K Basins Sludge Treatment Project Phase 1

Technology Readiness Assessment Report

November 16, 2009

Figure 3.1 Xago HydroLance⁽¹²⁾

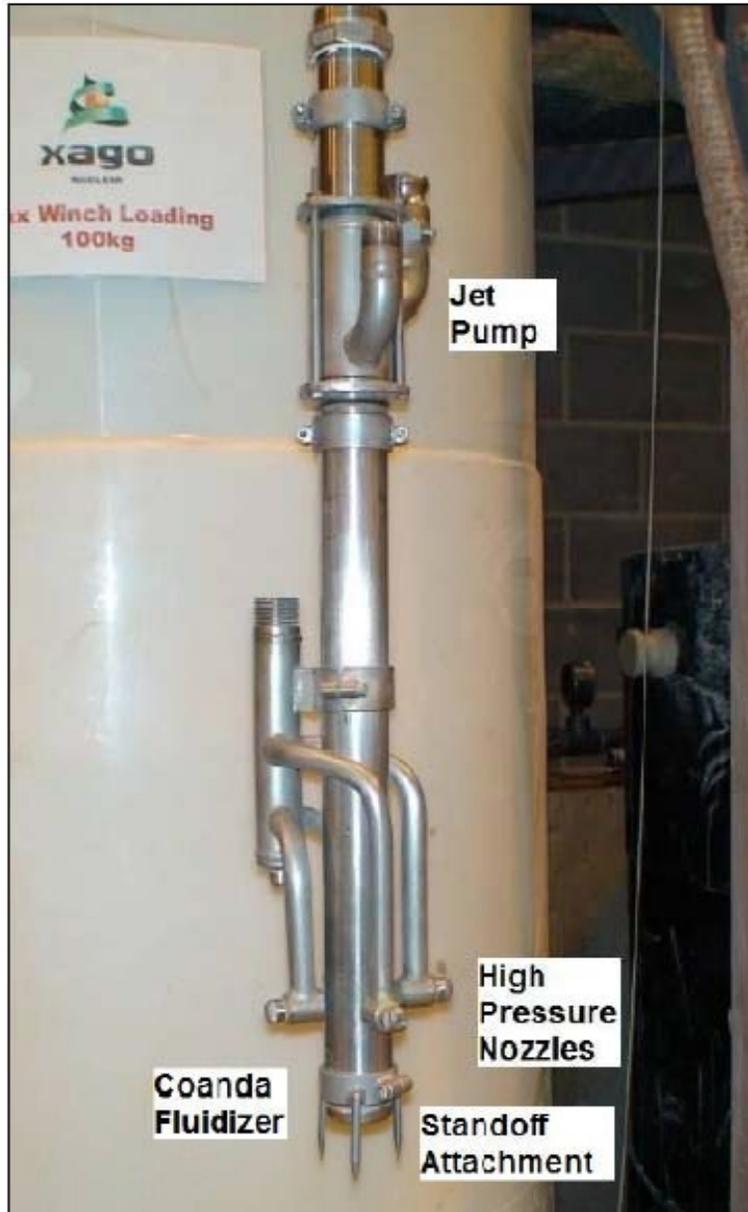
The HydroLance is a combined fluidizer and jet pump system manufactured by Xago Nuclear Ltd⁽¹²⁾. It consists of an adjustable annular jet pump to provide both suction and motive force to move the slurry, a low pressure “Coanda” fluidizer head to entrain solids at the suction end of the HydroLance, and an optional set of high pressure nozzles used to break up high shear strength materials.

The specific design for the STSC ORT has not been and is not planned to be demonstrated with actual waste. Testing with actual waste is not considered practical; however tools operating on similar principles have been used in the past in actual sludge transfer evolutions. The function and operation of the ORT tool will be further substantiated by testing with a full size ORT⁽¹⁶⁾ in simulants developed from a range of sludge characterization data selected to bound actual tool operations. Completion of the KW EC and Settler sludge characterization is still in progress and current simulants were developed based on historic sludge characterization data⁽¹⁷⁾. Until the sludge characterization results are completed verification that current simulants bound expected sludge properties cannot be confirmed.
